DART AEROSPACE LTD		Work Order:	100943
Description: Crosstube High Aft (205/212)		Part Number:	D212-664-201
Inspection Dwg: D212-664-241 Rev: D		Page 1 of 1

DRAWING NO. D212-664-241	TITLE CROSSTUBE ASSY (205/212 HI AFT)	REV. D	DART AEROSPACE LTD ENGINEERING ORDER		D.E.O. NO. D212-664-241-D-1	SHEET NO. SHEET 1 OF 2	SCALE NTS
DRAWN	CHECKED	MFG. APPR.	APPROVED	DE APPR.			
DATE 11.04.07	DATE 11.04.11	DATE 11.04.12	DATE 11/04/12	DATE 11.04.12

DRAWING NO. D212-664-241	TITLE CROSSTUBE ASS'Y (205/212 HI AFT)	REV. D	DART AEROSPACE LTD ENGINEERING ORDER		D.E.O. NO. D212-664-241-D-2	SHEET NO. SHEET 1 OF 1	SCALE INCHES
DRAWN 9	CHECKED ASS	MFG. APPR. 8	APPROVED MD		DE APPR. H		
DATE 11.07.15	DATE 11.07.20	DATE 11.07.21	DATE 11/27/21		DATE 11.07.21

**D212-664-241/-241B
ASSEMBLY DETAIL**

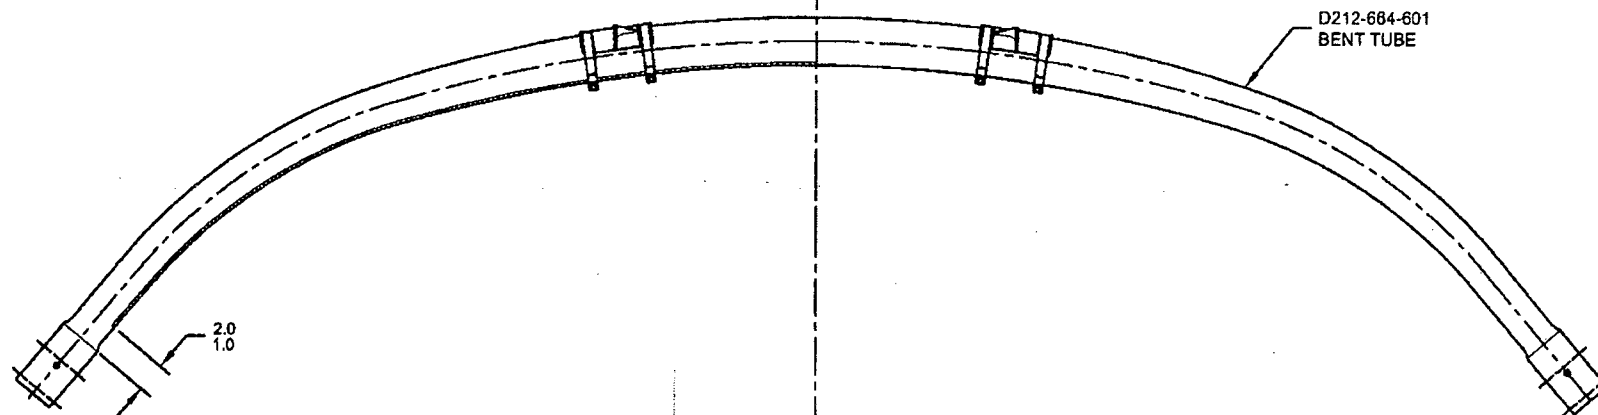
ADD AN INSPECTION WINDOW TO UNDERSIDE OF CROSSTUBE.

NOTES 2 OF SHEET 1 IS AMENDED AS FOLLOWS:

- 2) FINISH: CHEMICAL CONVERSION COAT PER DART QSI 005 4.1
PRIME INSIDE AND OUTSIDE PER DART QSI 005 4.2
MASK UNDERSIDE OF CROSSTUBE AS SHOWN (HATCHED AREA) AND
PAINT OUTSIDE PER DART QSI 005 4.2
REMOVE MASKING AND APPLY CLEAR COAT

MASK AREA PRIOR TO PAINTING,
REMOVE MASKING AFTER PAINT
AND APPLY CLEAR COAT

FIGURE 1: SUPPORT INSTALLATION

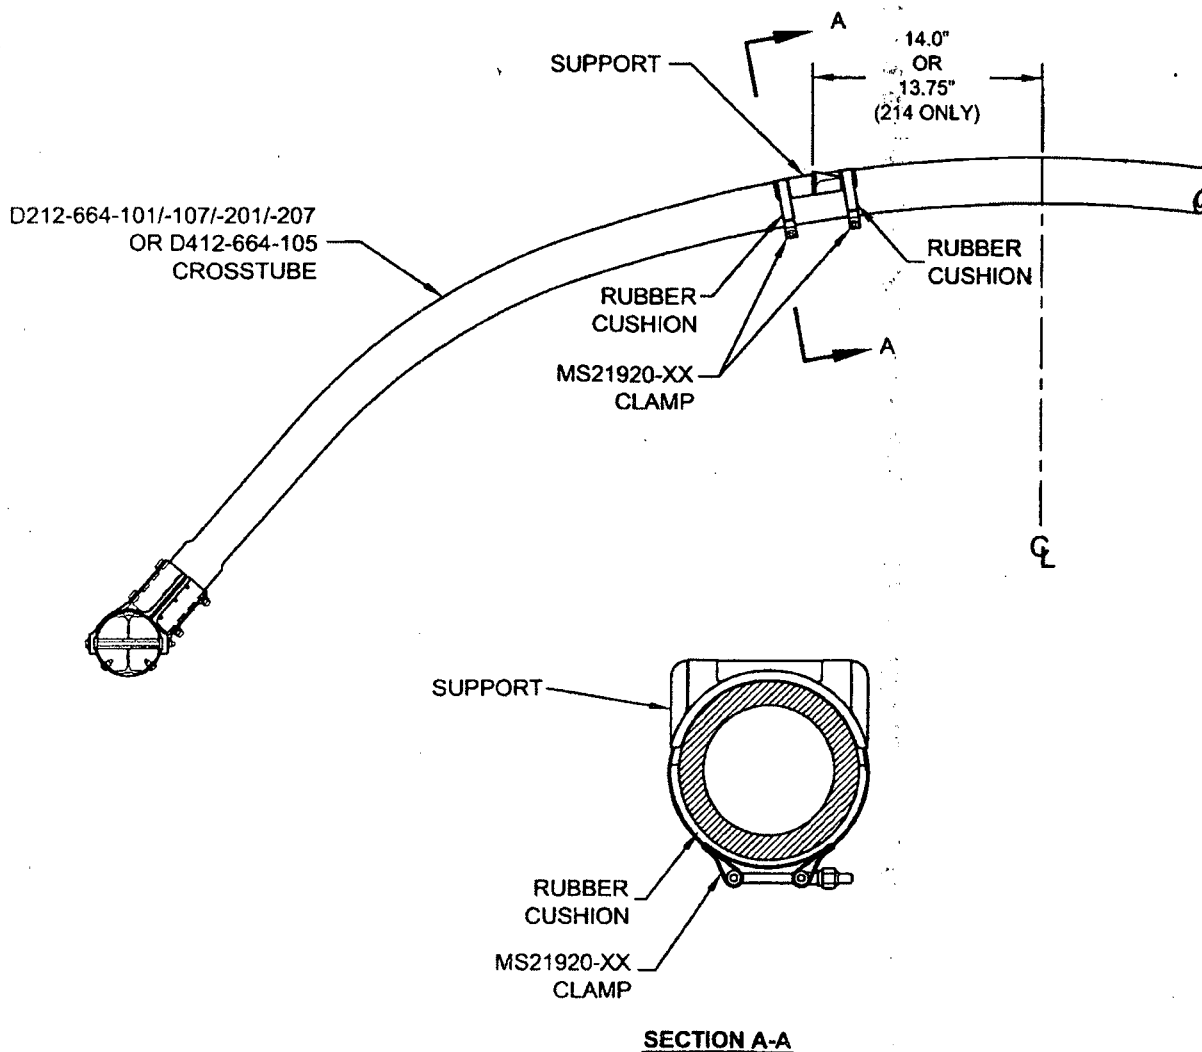
For the crosstubes listed above, section 32.4 of ICA-D212-664 is amended as follows. Use Figure 1 of this service instruction and Figures 32-2 to 32-9 of ICA-D212-664 for further reference. For crosstubes of an earlier change number, it is recommended that if the supports are removed, the supports should be reinstalled using the procedure listed below.

- 32.4.1 Locate the area on the crosstube for installation of support (see Figure 1 of this service instruction). For D212-664-101/-107/-201/-207 and D412-664-105 crosstubes, the outward face of the support tabs should be 14.0" (355mm) from the crosstube center for 204/205/210/412/UH-1 aircraft. For installation on 214B/B-1 aircraft, the outward face of the support tabs should be 13.75" (349mm). Ensure paint finish of crosstube is intact; touch up as required per Chapter 5 (5.3.9) of ICA-D212-664.

- 32.4.2 If present, remove any paint/primer on bottom of supports. Abrade mating surfaces of support and crosstube with 400-grit sandpaper. Saturate a clean cloth with MEK or 4105S Wash'n'Wipe Degreaser or equivalent and wipe until there is no residue.

- 32.4.5 Apply a 0.04" to 0.07" thick layer of Proseal 890 Class B or AMS-S-8802 Class B sealant underneath applicable support and install support as shown in Figure 1 of this service instruction.

- 32.4.6 Install the clamps opposite to crosstube support as shown in section A-A of Figure 1. Install rubber cushions underneath each clamp around the bottom circumference of the crosstube up to the crosstube centerline. Torque clamps 80-100 in-lb (9.0-11.3 Nm). It is acceptable to use smaller or larger sized MS21920-XX clamps than those listed in ICA-D212-664, ensure that after torquing the clamps per this instruction, the nuts are in safety but not bottomed out

CRUSHING OF D212-664-201

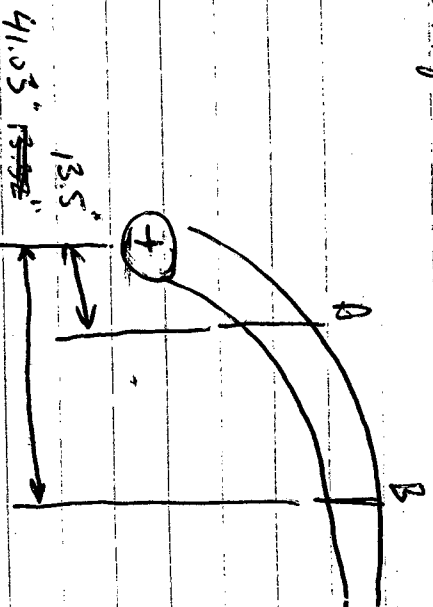
Acceptability of 8% CRUSHING

Point A: $OD = 2.548$ in $OD = 2.442$ in
